**Subject: DEVIATION REVIEW AND DECISION FORM**

Subdivision or Project Name: Winsome

Section of ECM from Which Deviation is Sought: Section 2.25.B.1 Spacing for Rural Minor Arterial

# Winsome

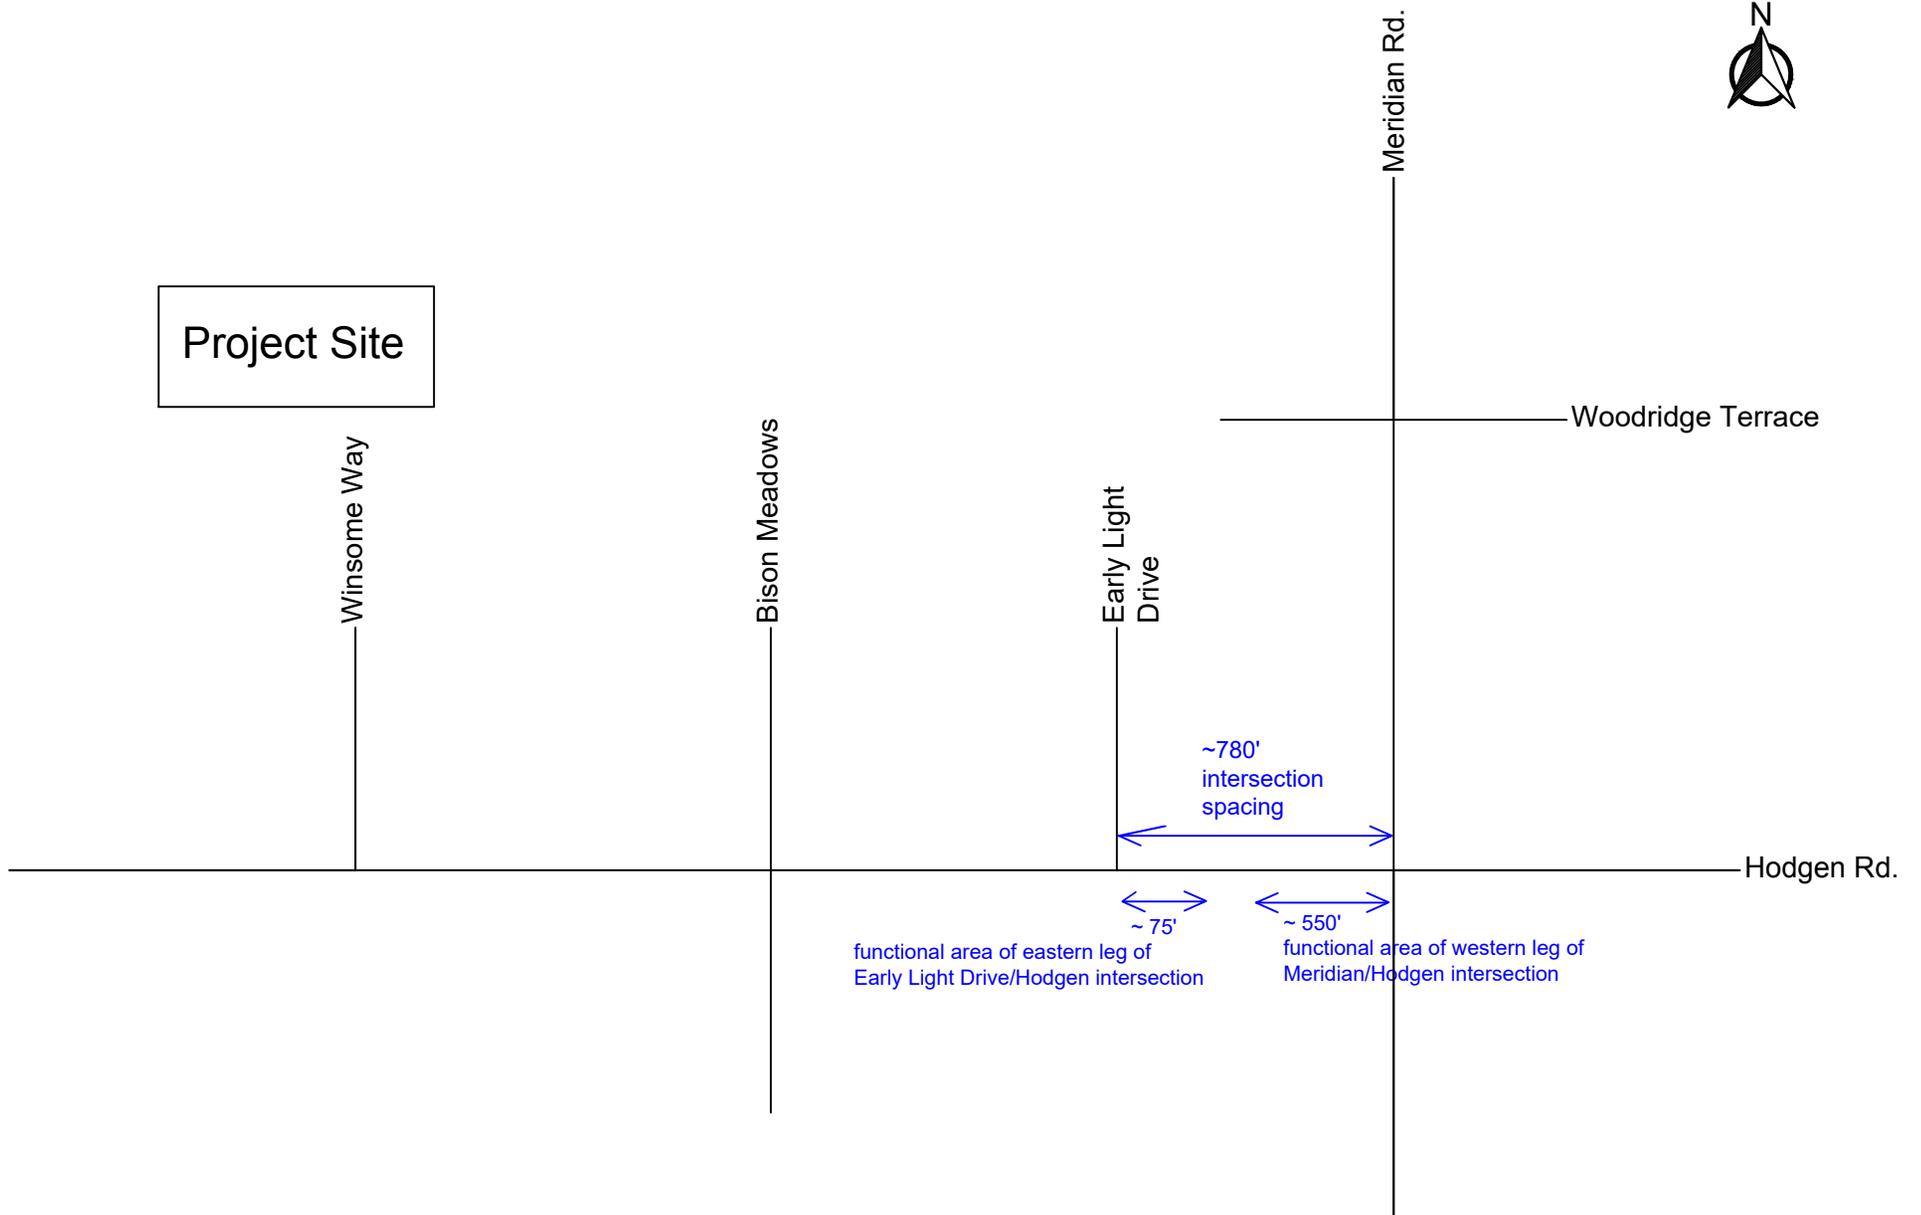
Elaborate on the justification/reason. There are two other access points on Hodgen plus one on Meridian Road. With a large undeveloped property there is sufficient room to reconfigure internal roads to provide access to the commercial lot without the 3rd intersection on Hodgen. Explain why the internal roadway can't be reconfigured so the third access (Early Light Drive) on Hodgen is not required.

Expand by providing a detailed explanation on how each criteria have been satisfied. Example: Simply stating the deviation does not affect aesthetic appearance is insufficient. You must explain how or why it does not affect the aesthetic appearance.

Separate the explanations into five paragraphs addressing each specific criteria.
